From: Philip Forster
Sent: 26 July 2018 11:48
To: planning_admin
Subject: FW: P/2018/0429 - Asney park Farm

Flood officer response
Confirmation that the site is in TAN15 Zone B

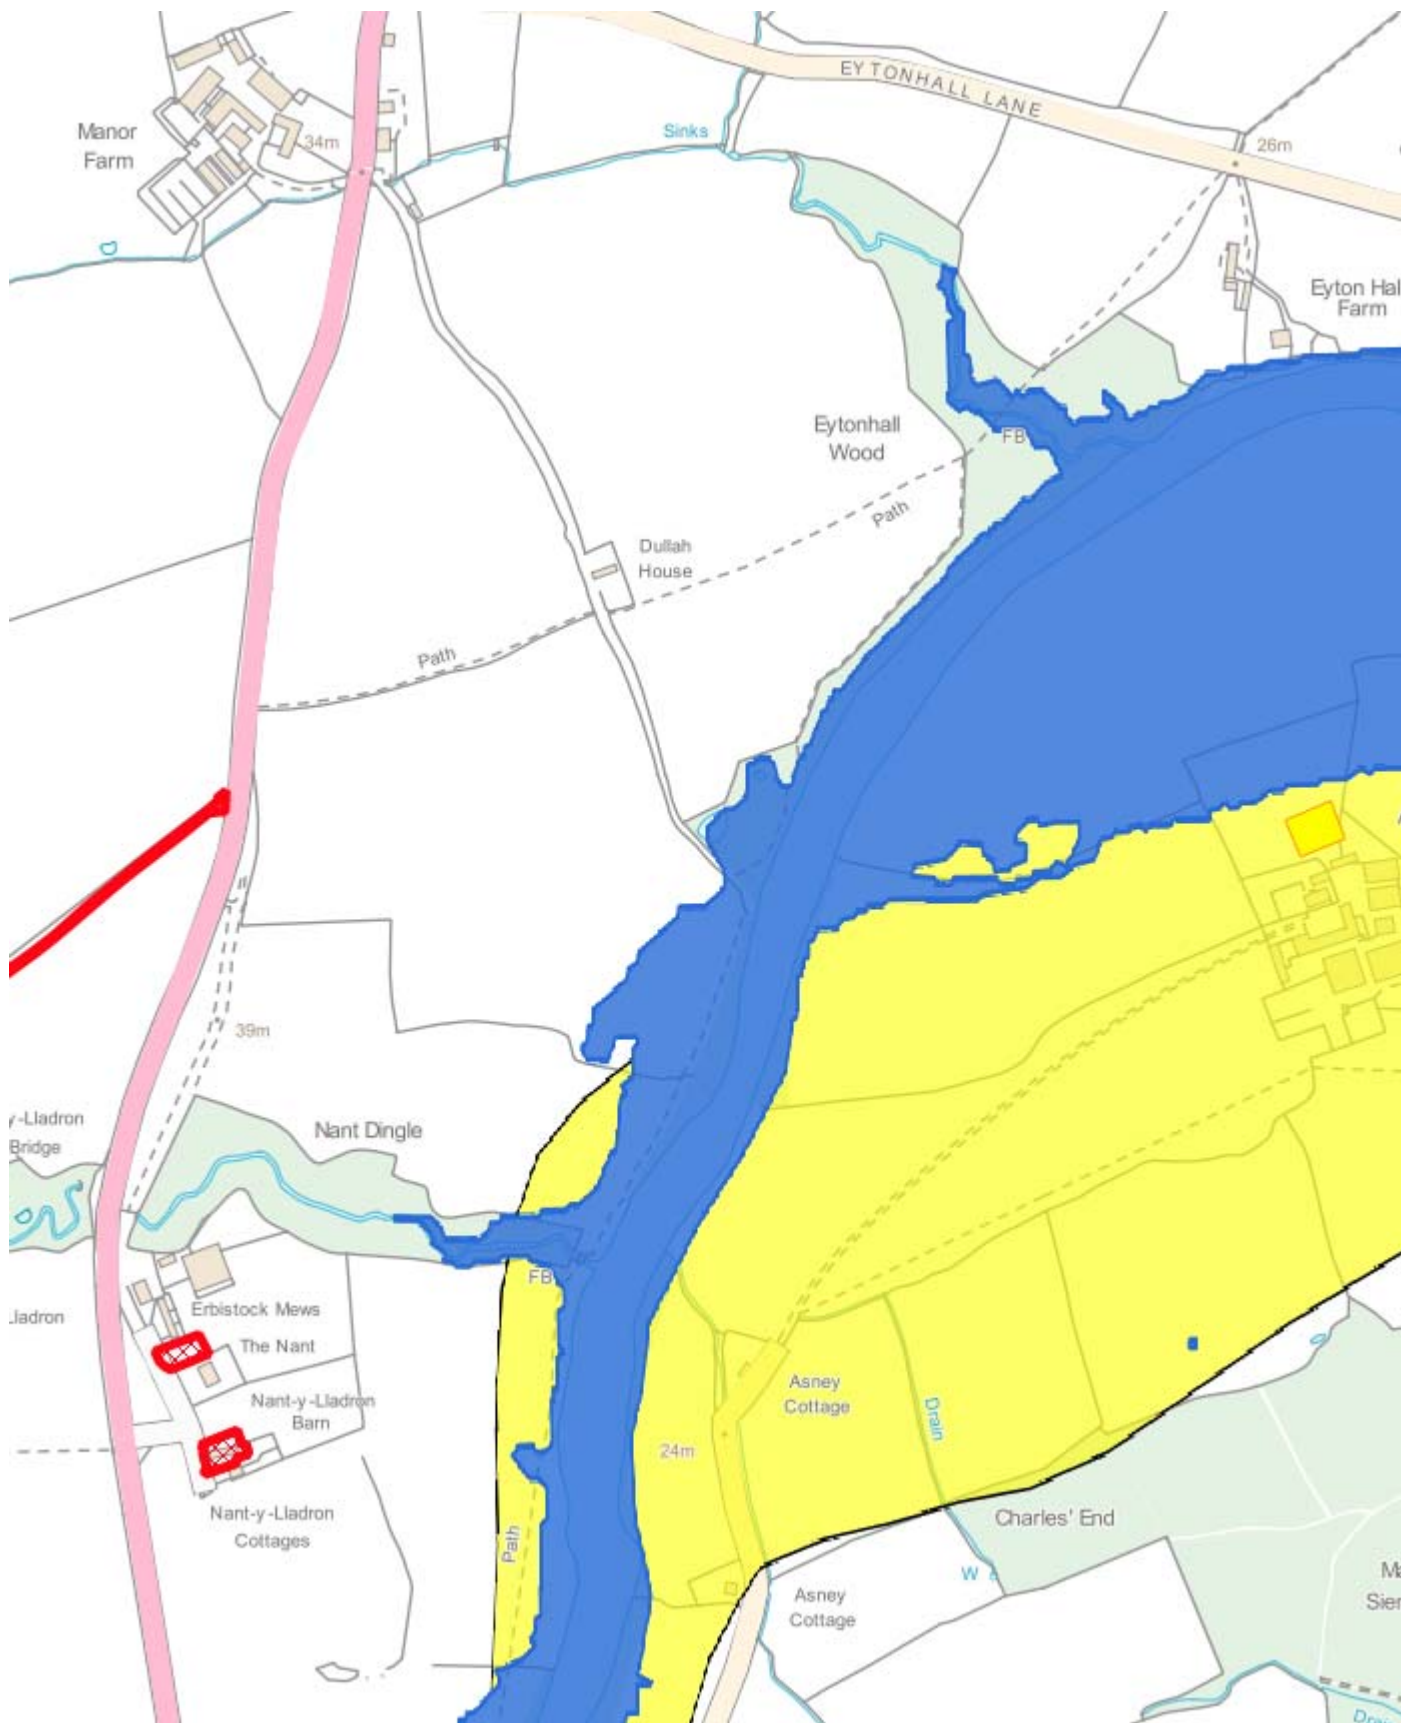
Extract of the DAM below – Blue = C2, Yellow = B. Close to C2 but not within.

You've referred to the site as TAN15 Zone B. Our Proprinter layer is showing it as C2. NRW haven't raised any concerns so I'm wondering whether our layers are out of date.
